Sprue bushes

Produktänderung
Product modification
Modification des produits

Z37-

Z37-Type

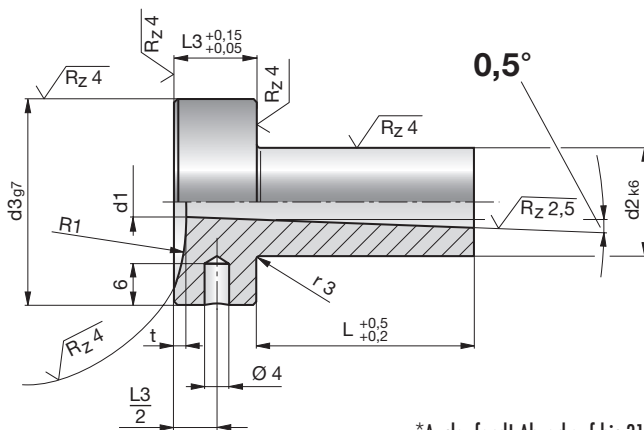
*Auslaufend! Abverkauf bis 31.12.2023.
Discontinued! Sales until 31.12.2023.
Discontinu  ! Ventes jusqu'au 31.12.2023.

Z37-Type

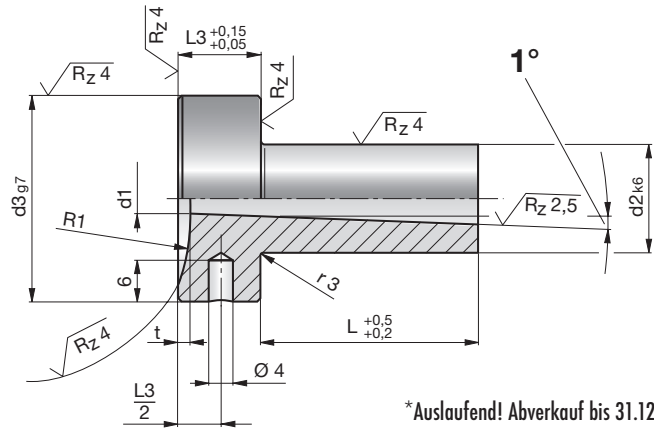
*Auslaufend! Abverkauf bis 31.12.2023.
Discontinued! Sales until 31.12.2023.
Discontinu ! Ventes jusqu'au 31.12.2023.
